Mountain View Hospital

2nd Submittal

| <b>INTER-OFFICE MEMORANDUM</b>                                             |                                    | November 17, 2015                                                                                 |
| <b>Mountain View Hospital – Medical Office Building Update</b>             |                                    | <b>COPIES TO:</b>                                                                                 |

Figure 1

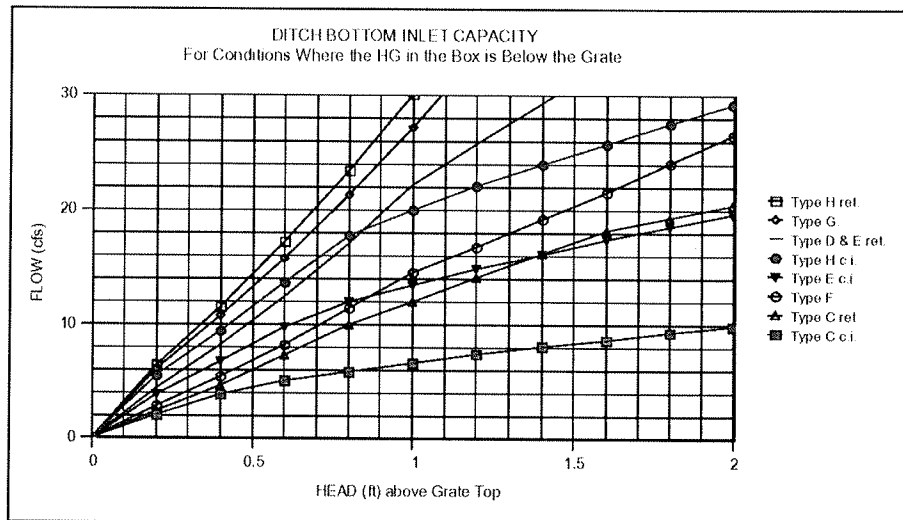
The capacity of an inlet was analyzed using the table in Figure 1 for a Type C (ret) inlet, which is equivalent to an NDOT Type 2 structure. Referencing [Figure 1](#), a Type C (ret) inlet requires 0.6± ft. of head to drive 8 cfs through the structure's opening. Therefore the 0.6-ft hydraulic gradient above the top of the grate must be provided for. Please be aware that Note 2 of [Figure 1](#) indicates that the grate is considered 50% blocked, thus providing factor of safety in flow across the grate.

| SHEET            | C6.0                    |

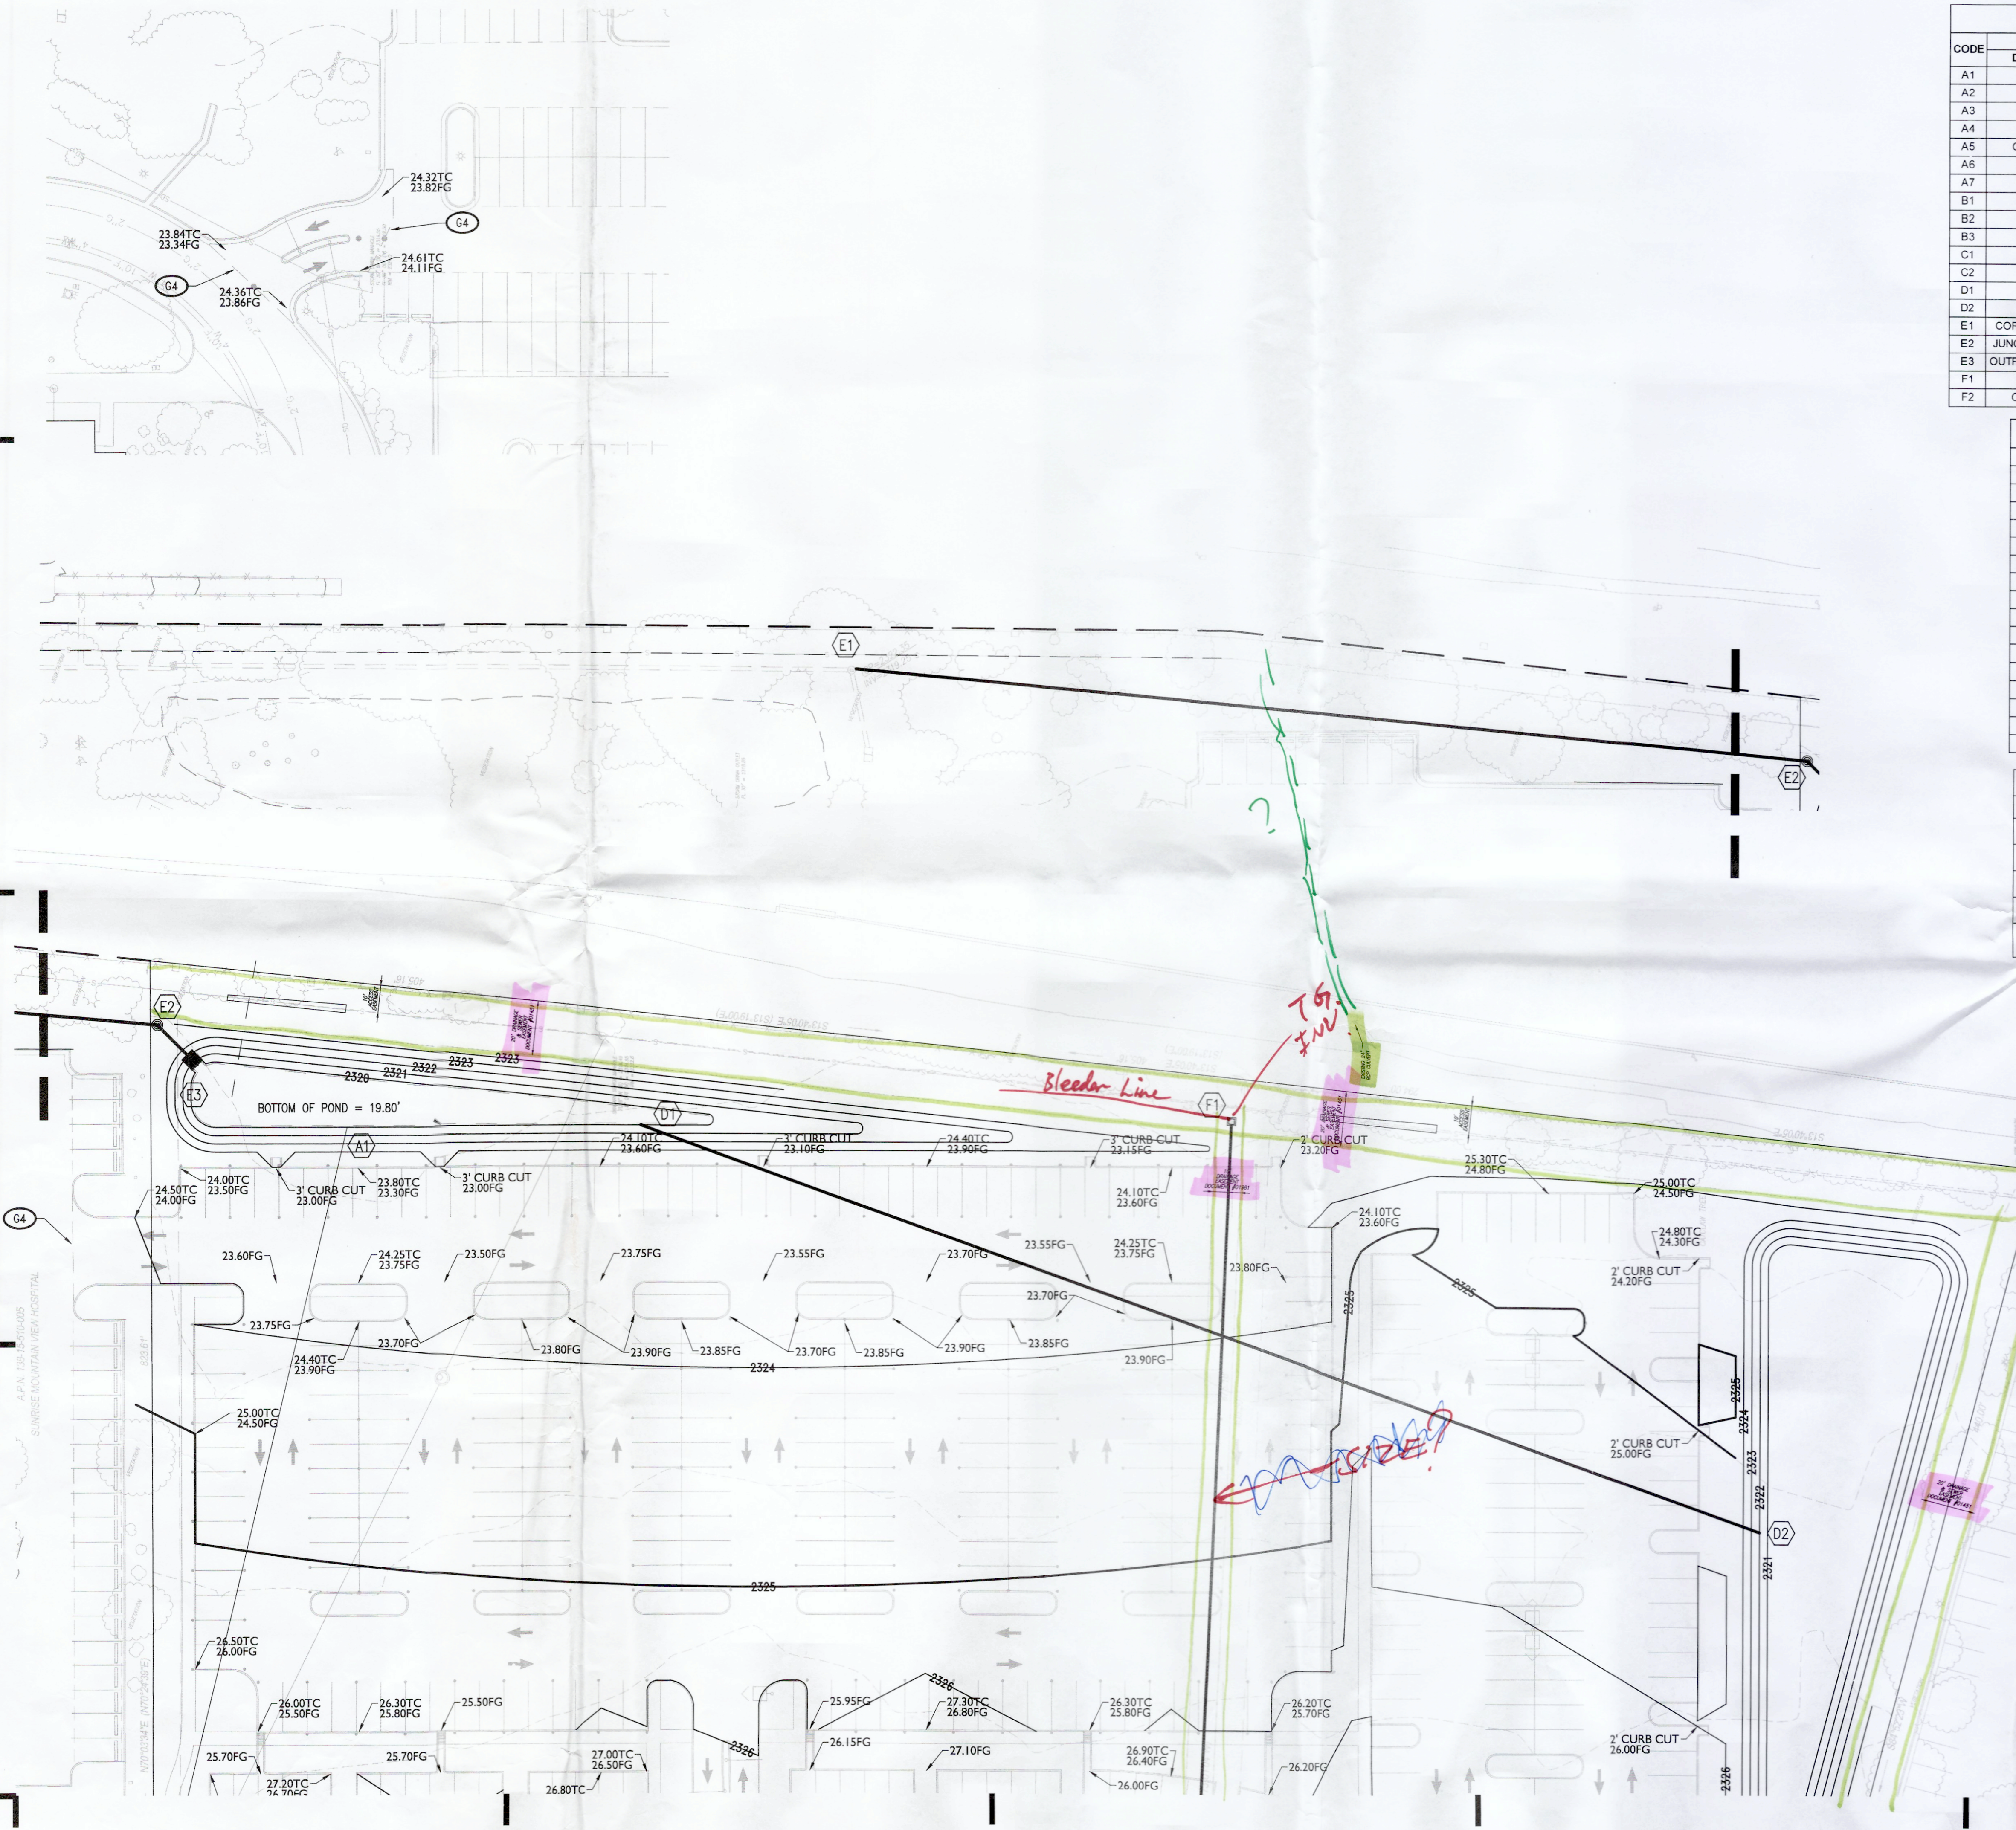
3. **Sheet C6.1:** Identify the property line of the adjacent property to the west.
4. **Sheet C6.0:** Provide a bleeder line at drainage facility "F1" to daylight the flow.

5. **Second request: Sheet C6.0:** Identify an existing 24"-RCP culvert crossing **US95** located at about the middle point of the east boundary of the project site. Label with recorded drawing number on the plan.

Address in the addendum of the study whether this culvert is accepting any flow of the proposed development.

**Comment 7:** Sheet C6.0: Per the grading design, it appears that the proposed local detention pond at the southeast corner of the site is not accepting much flow from onsite. Address the necessity of such detention in regulating the proposed developed condition flows in the next submittal.

**Comment 10: Sheet C6.0: Identify and existing 24"-RCP culvert crossing US95 located at about the middle point of the east boundary of the project site. Label with recorded drawing number on the plan. Address in the addendum of the study whether this culvert is accepting any flow of the processed development.**

**Response 7:** These are interconnected ponds that act as one for the purposes of BMP's and to attenuate flow increase. Under existing conditions the runoff is Q100/Q10 of 8-cfs/4-cfs, the developed condition runoff routed through the detention pond is 8-cfs and 4-cfs

Response 10: Culvert is shown on plans.

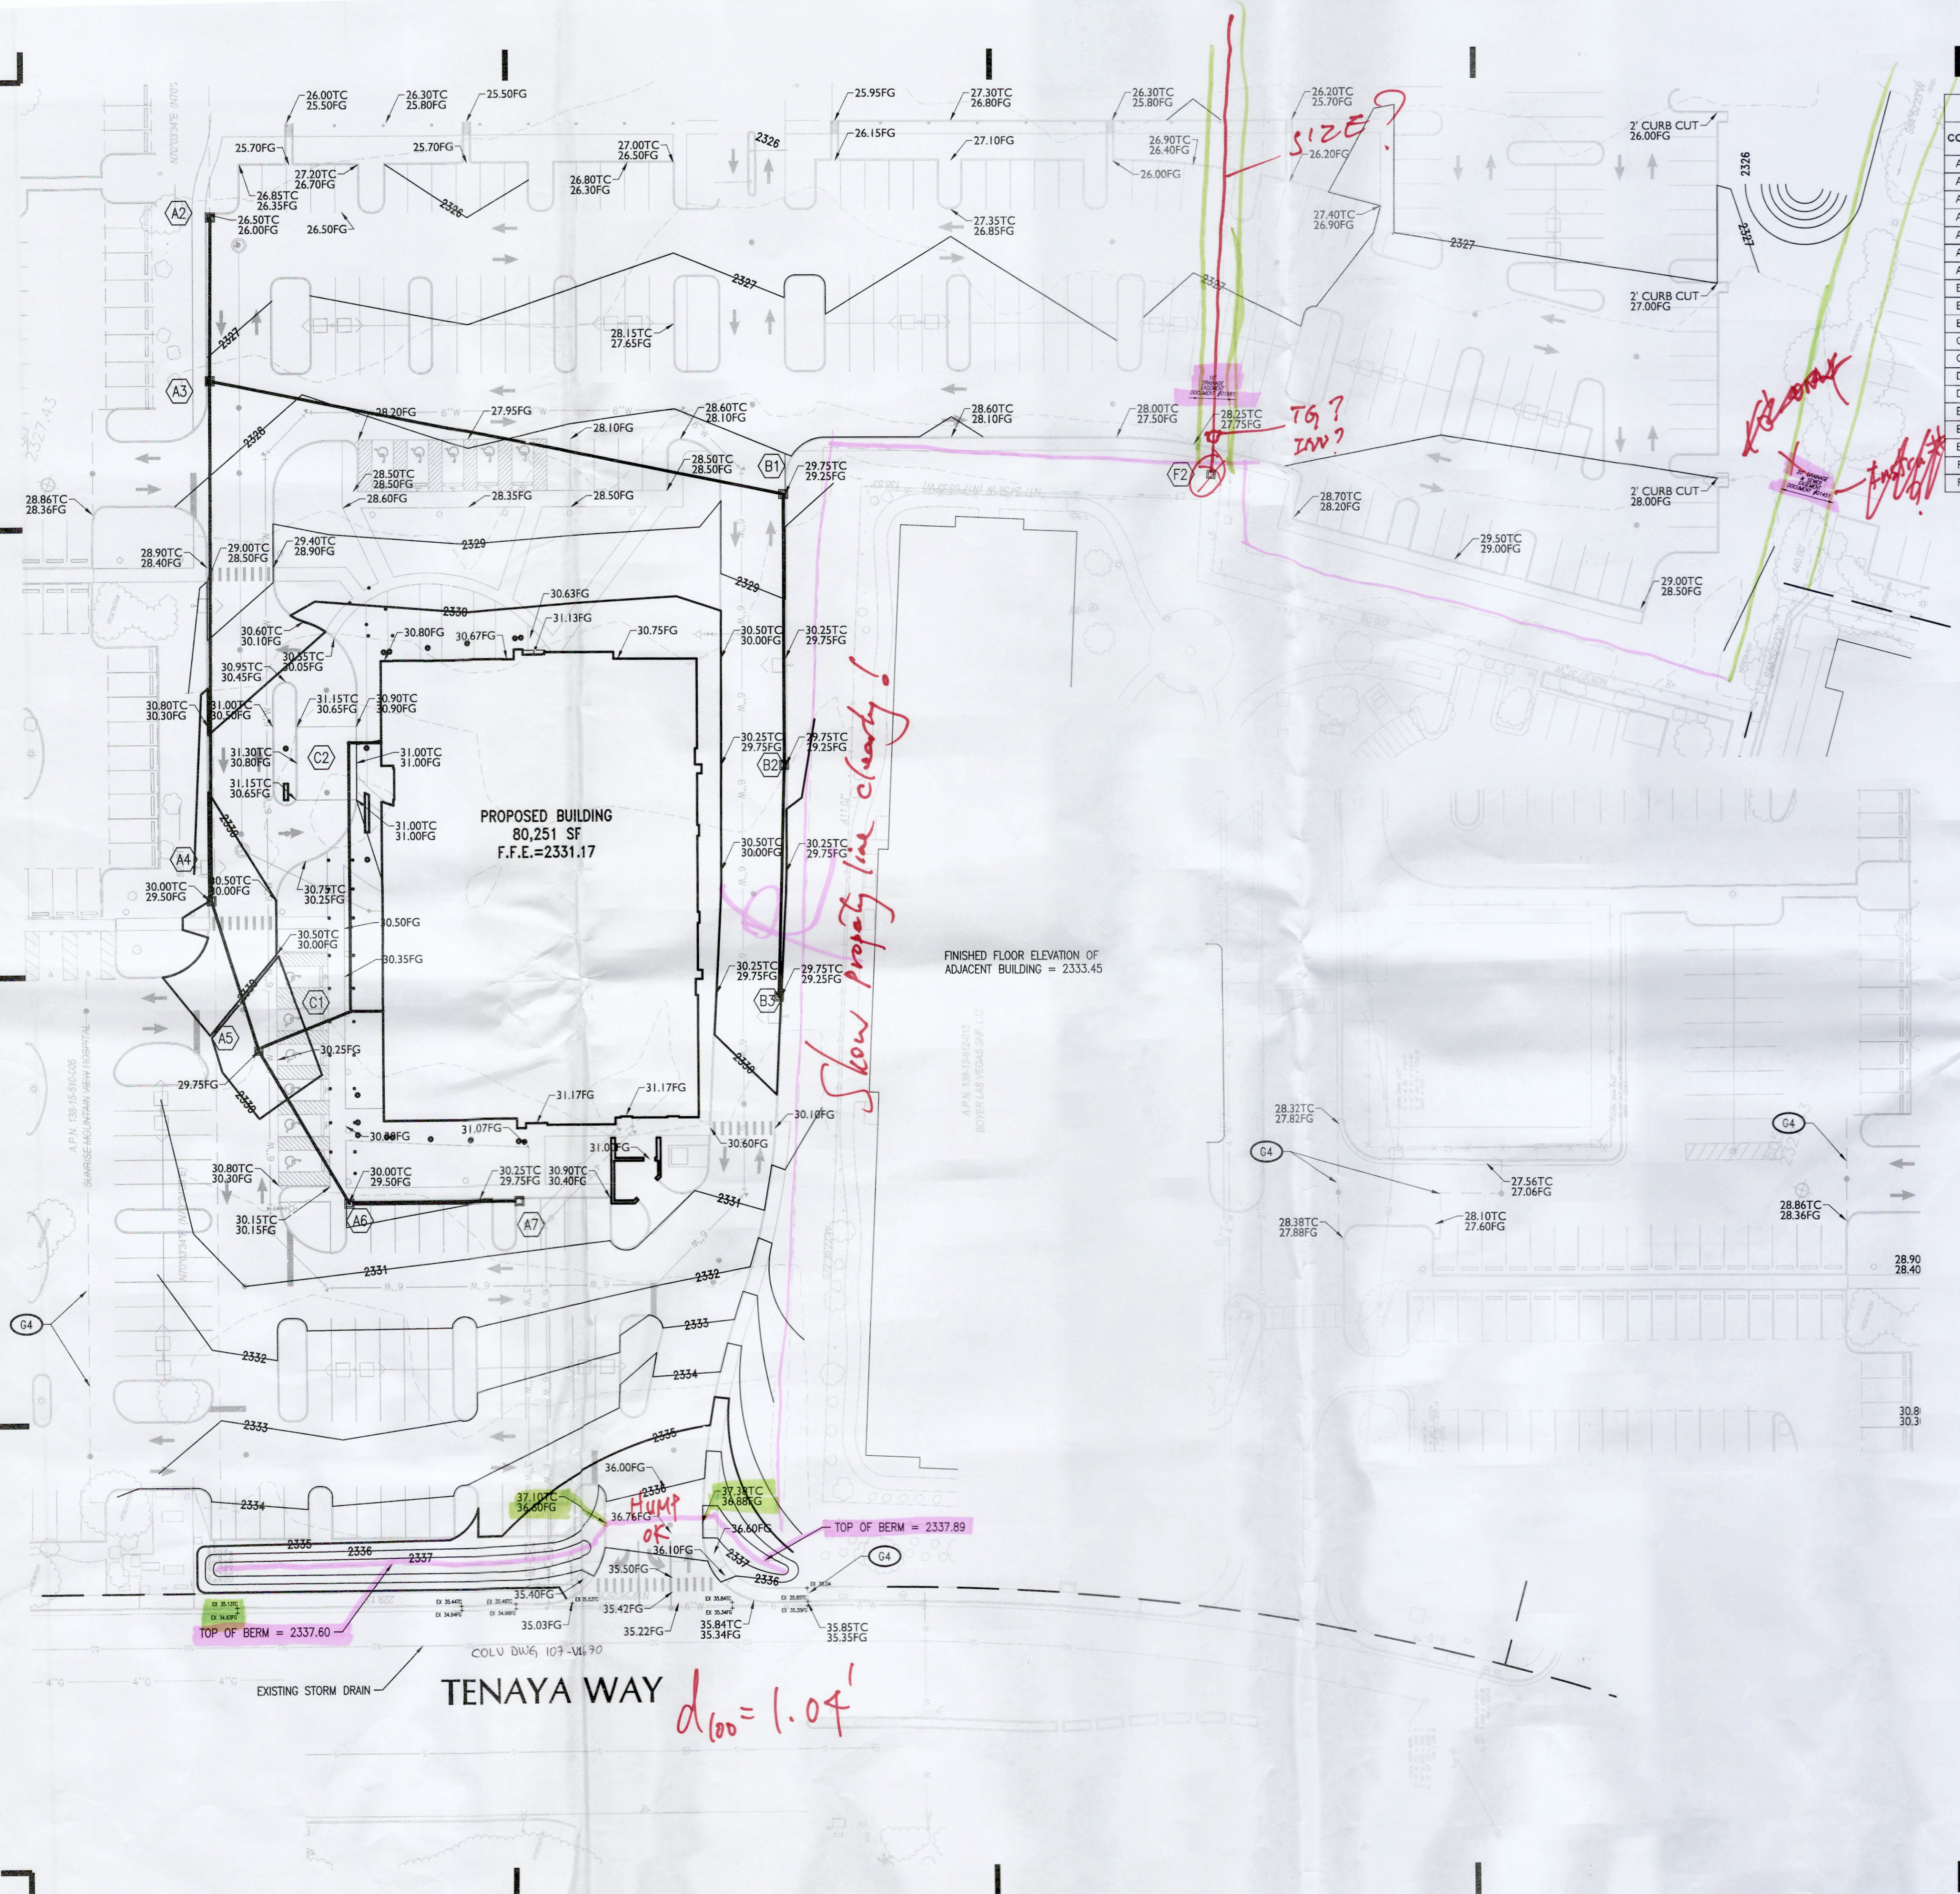
2. **Sheet C6.1:** It appears that drainage facility "F2" is located in the adjacent property. Either obtain a notarized letter of permission for construction from the adjacent property owner or relocate the inlet easterly into the subject site. Review and revise accordingly. Also, explain why the proposed inlet is so deep.

Why that deep?
